BEACON VILLAGE - RE-USED DRAINAGE PLAN (PARKWOOD SYSTEM TO MAINS GATE)

DRAINAGE & UTILITY PLAN

BEACON VILLAGE	Drawn: JNJ
	DRAINAGE & UTILITY PLAN	Checked: RSM/KKL
		Date: 4.25.89
		Scale: AS SHOWN

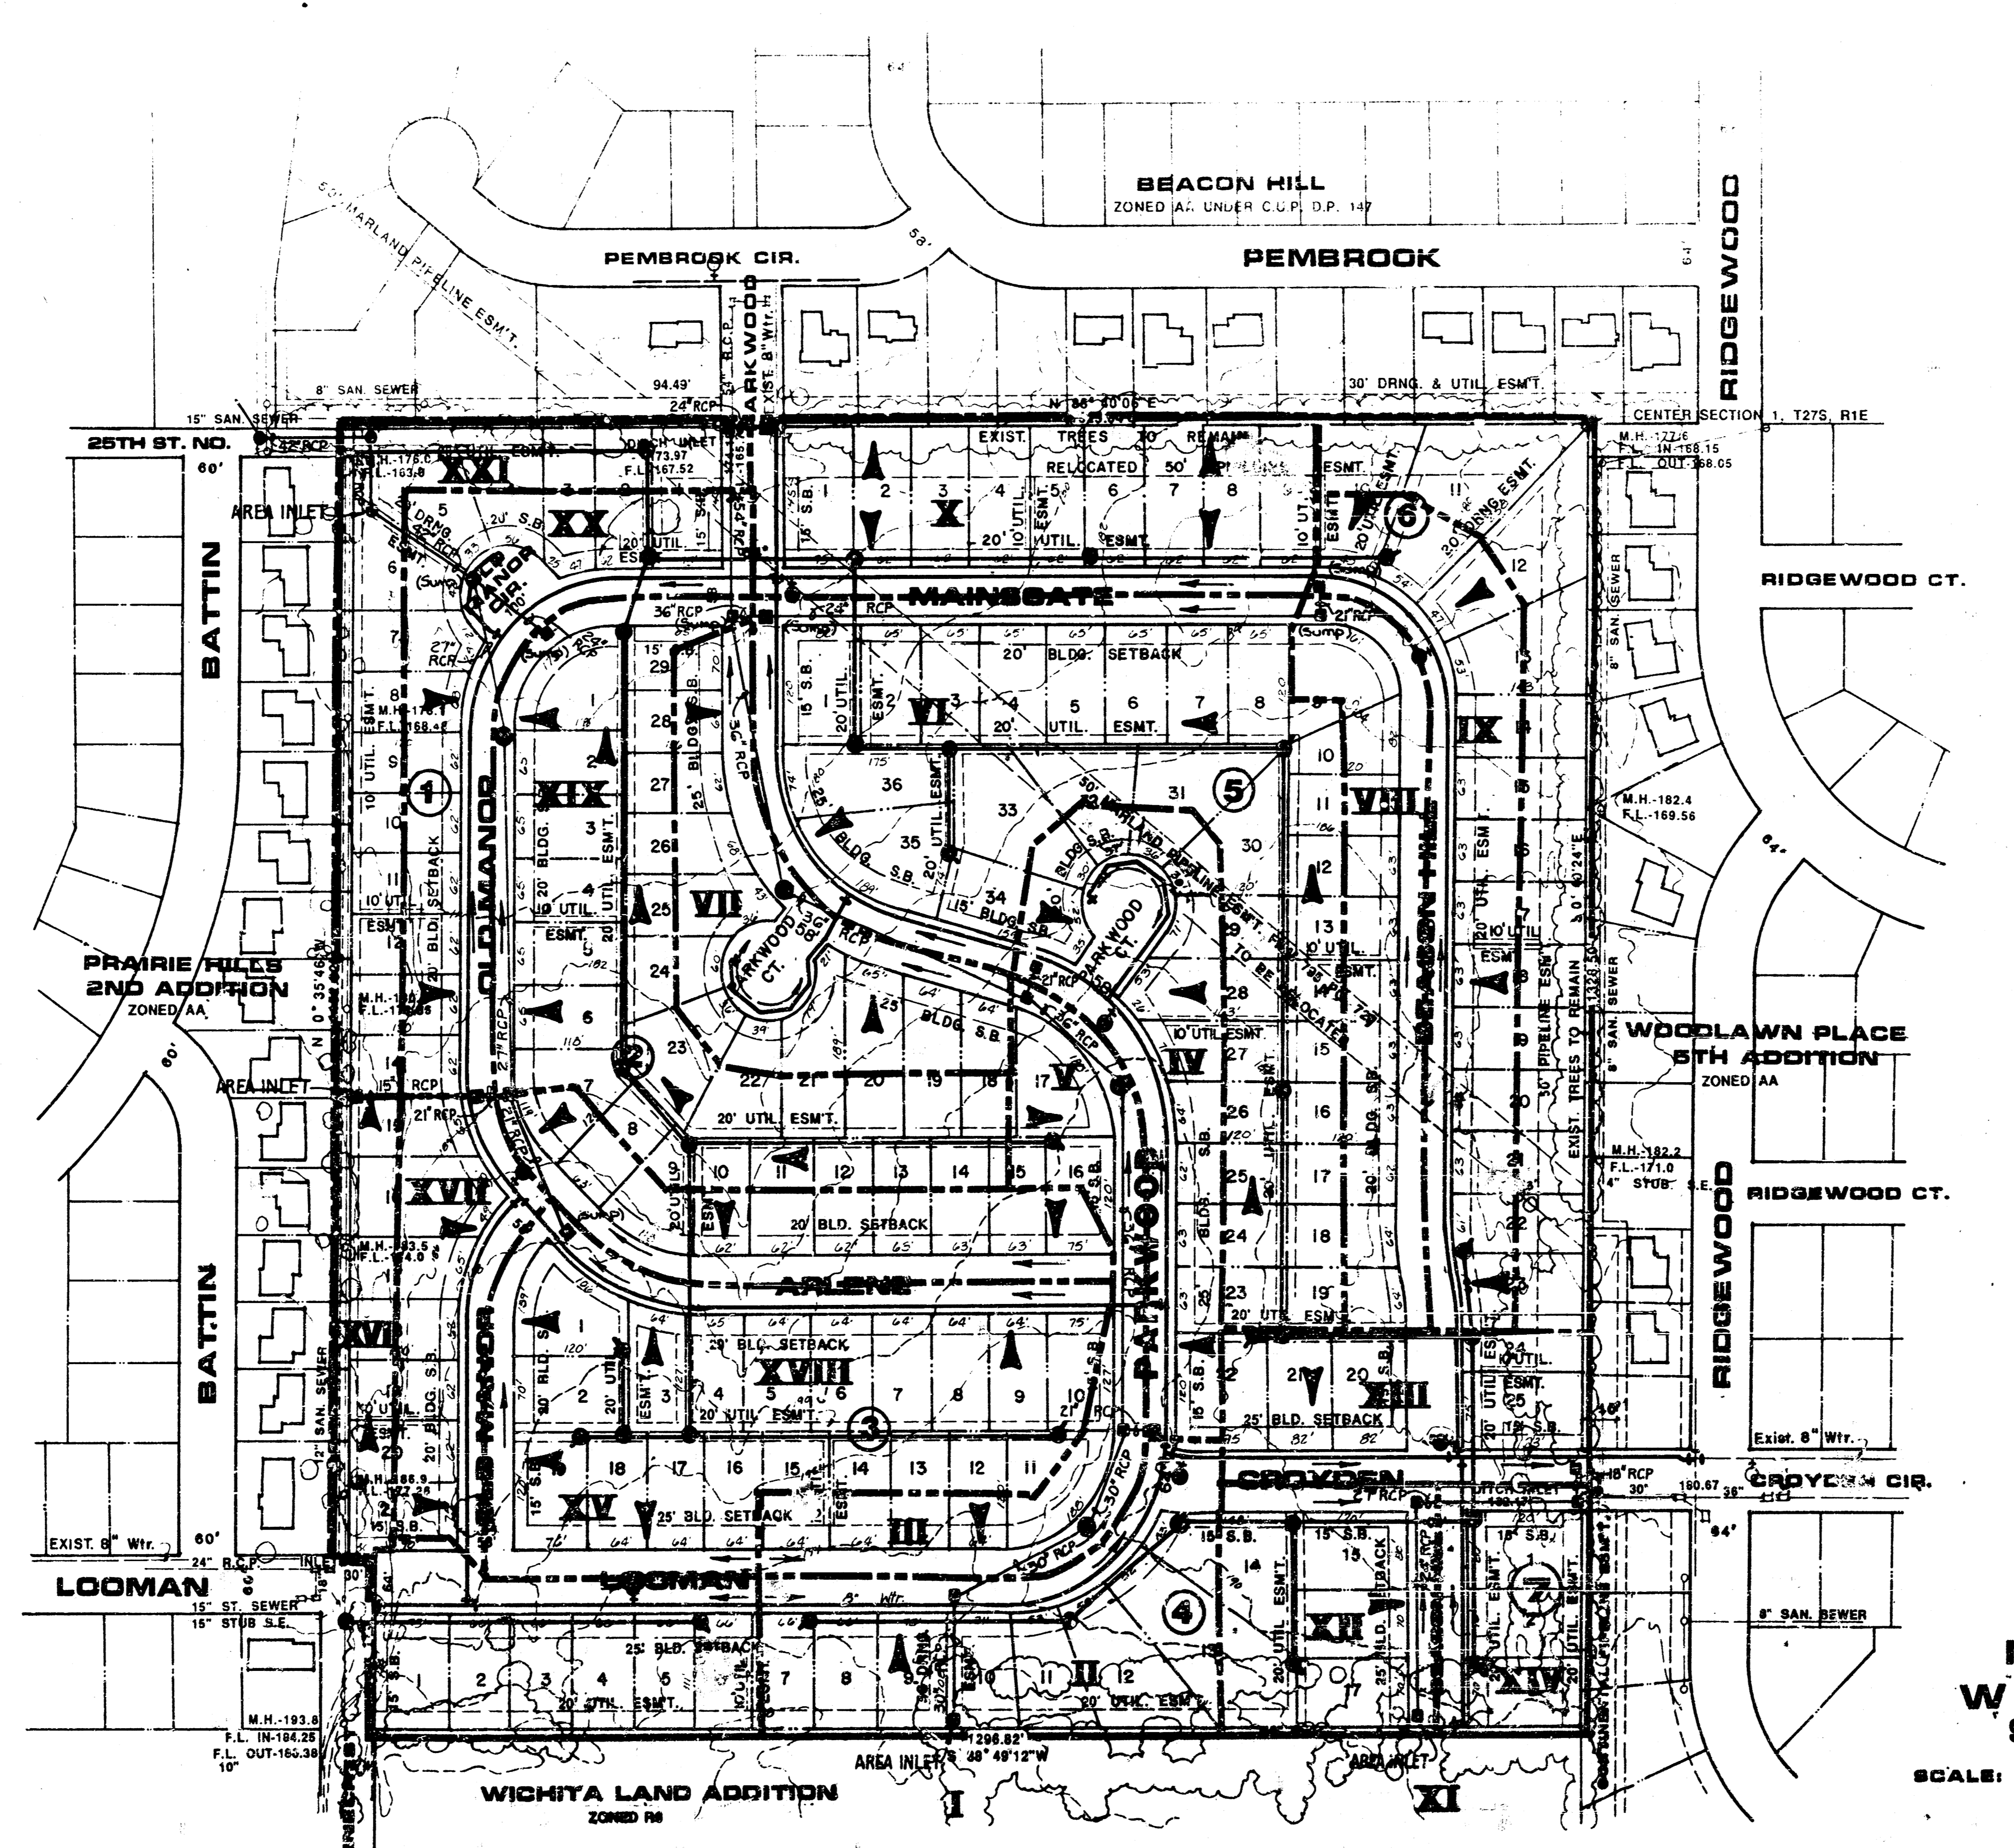
1. Review the contract documents and the site plan and show the location of the proposed water sewer improvement district boundary.
2. Provide a plan showing the proposed water sewer improvement district boundary and the location of the proposed water sewer improvement district boundary.
3. Provide a plan showing the proposed water sewer improvement district boundary and the location of the proposed water sewer improvement district boundary.
4. City of Wichita will require the water sewer improvement district boundary to be shown on the site plan.
